From: [Billings, Bradford, EMNRD](#)
To: [Camille J Bryant](#)
Cc: [Amber L Groves](#); [Yu, Olivia, EMNRD](#)
Subject: RE: Plains Pipeline 8" Moore to Jal #1 Release Site NMOCD Ref. # AP-91
Date: Tuesday, February 27, 2018 10:34:10 AM

Re: Plains Pipeline 8" Moore to Jal, Release Site NMOCD Ref.# AP-91, Lea county.

8" Moore to Jal #1
 SRS # 2002-10270, NMOCD REF. # AP-91
 9.2 Miles SE of Lovington, NM, Lea County, New Mexico
 Figure 2d - Groundwater Gradient Map (12/13/2017)

8" Moore to Jal #1
 SRS # 2002-10270, NMOCD REF. # AP-91
 9.2 Miles SE of Lovington, NM, Lea County, New Mexico
 Figure 4 - Proposed Monitor Well Locations

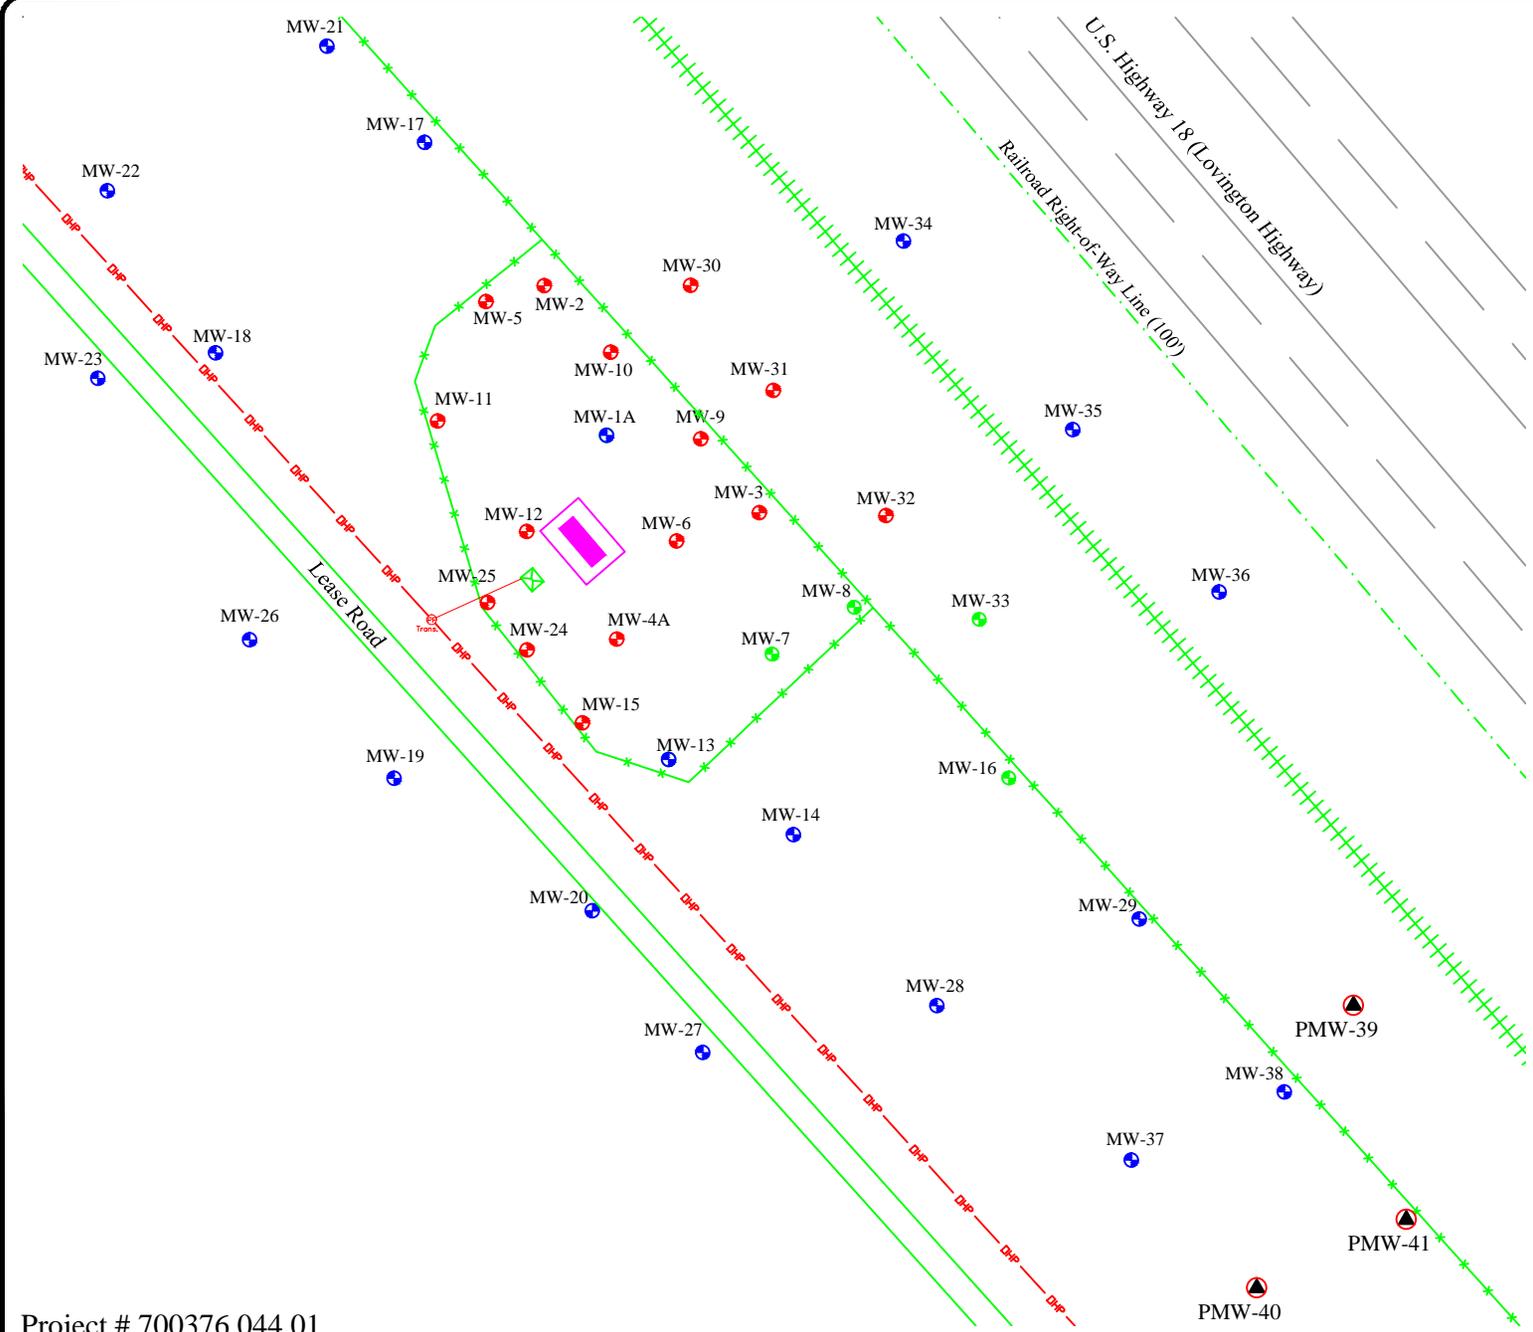
Plains Pipeline, L.P., respectfully requests NMOCD approval to conduct the following activities at the 8" Moore to Jal #1 Release Site NMOCD Ref# AP-91. Plains proposes to install three (3) additional monitor wells (PMW-39, PMW-40, and PMW-41) at the site. The proposed monitor wells will aide in plume delineation and groundwater remediation efforts at the site. Monitor well PMW-39 is

proposed to be installed to the northeast of existing well MW-38, PMW-40 is proposed to be installed to the south-southeast of existing well MW-37, and PMW-41 is proposed to be installed to the south of existing well MW-38. Please reference the attached Proposed Monitor Well Locations Map, Figures 2 and 3.

The work effort detailed on this email stream and in supplied documentation is hereby approved. Please provide District office with timely opportunity to attend installation of said wells and sampling.
